TIE-LINE 637 WOOD-TO-STEEL PROJECT

MINOR PROJECT REFINEMENT REQUEST FORM

Date Requested:	April 9, 2014	Report #:	001
Date Approved:	April 10, 2014	Approval Agency:	CPUC
Property Owner(s):	County of San Diego Road (Creelman Lane) – Franchise Position	Location/Milepost:	Structure No. P5
Land Use/ Vegetative Cover:	Road shoulder covered by bare ground and previously disturbed habitat dominated by non-native species	Sensitive Resources:	<ul style="list-style-type: none"> • [REDACTED] • Noise sensitive areas
Refinement / Modification From (check all that apply):			
<input type="checkbox"/> Permit	<input type="checkbox"/> Plan/Procedure	<input type="checkbox"/> Specification	<input type="checkbox"/> Drawing
<input type="checkbox"/> Mitigation Measure (MM)			
<input checked="" type="checkbox"/> Other: Structure Type			
Structure No. P5 was originally designed to be a micropile (engineered) steel pole structure, and was described as such within SDG&E’s application for a Permit to Construct (PTC) for the TL 637 Project (refer to Proponent’s Environmental Assessment Appendices 3-A and 3-B) and within the Mitigated Negative Declaration (MND) for the Project (refer to the TL 637 MND, Attachm

Photograph 1: Existing location Structure No. P5 facing southeast

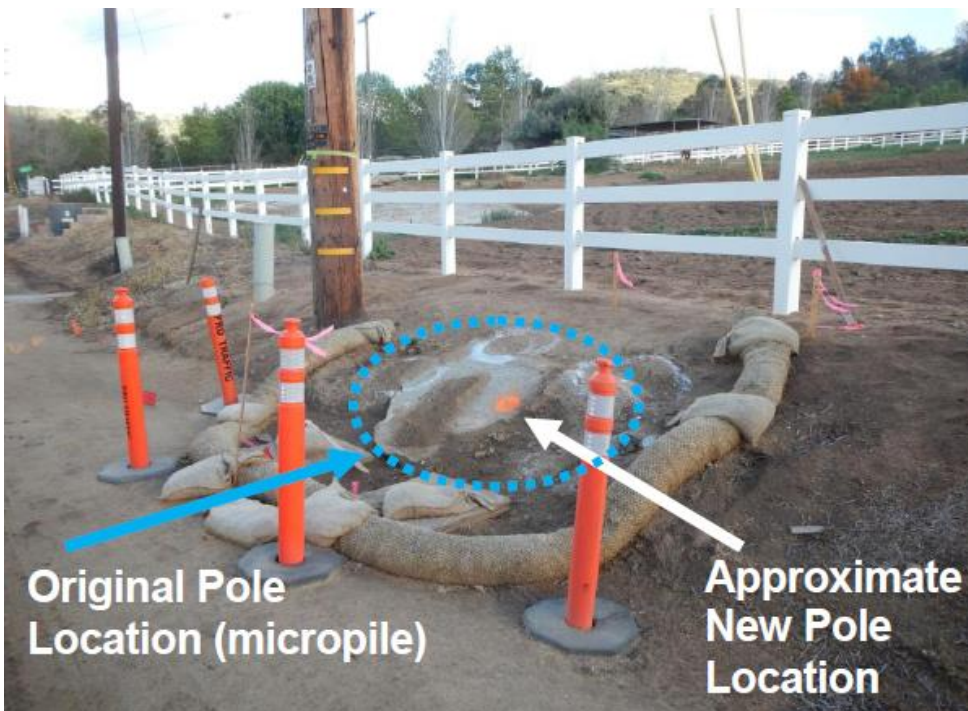
Description of Refinement			
Structure No. P5 needs to be changed to a directly-embedded steel pole in order to avoid existing underground utilities and remain within existing franchise position at the structure location. The new directly-embedded Structure No. P5 would be located in approximately the same location and would be approximately 97 feet above grade.			
Original Condition:			
Structure No. P5 was included within the PTC application and CEQA MND as a micropile structure that would be approximately 100 feet above grade.			
Justification for Change:			
Following potholing (preliminary excavation conducted to verify the condition of underground facilities at a given location) at the Structure No. P5 location, construction crews discovered that existing underground utility lines were further south than anticipated and were within the anticipated footprint of Structure No. P5, a proposed micropile pole. Structure No. P5 was located within franchise position (County of San Diego maintained Creelman Lane) and there is not sufficient space within the Creelman Lane right-of-way (ROW) to place a micropile structure given the exact location of the existing underground utilities. Therefore, SDG&E is proposing to change Structure No. P5 to a directly-embedded steel pole. The directly-embedded steel pole structure can be installed within existing franchise position, south of the existing underground utilities. Structure No. P5 cannot be installed within existing franchise position as the micropile is currently designed, and would thus require new ROW. Photographs 1 and 2 depict the Structure No. P5 location, including the approximate location of the new directly-embedded structure.

The new directly-embedded Structure No. P5 would be located in the same location as the originally designed micropile structure (see Photographs 1 and 2 below).

Structure No. P5 designed as a directly-embedded structure would result in less anticipated temporary and permanent disturbance areas. Anticipated disturbance areas for the re-designed Structure No. P5 would be approximately 304 square feet of temporary disturbance area and approximately 10 square feet of permanent impact area.
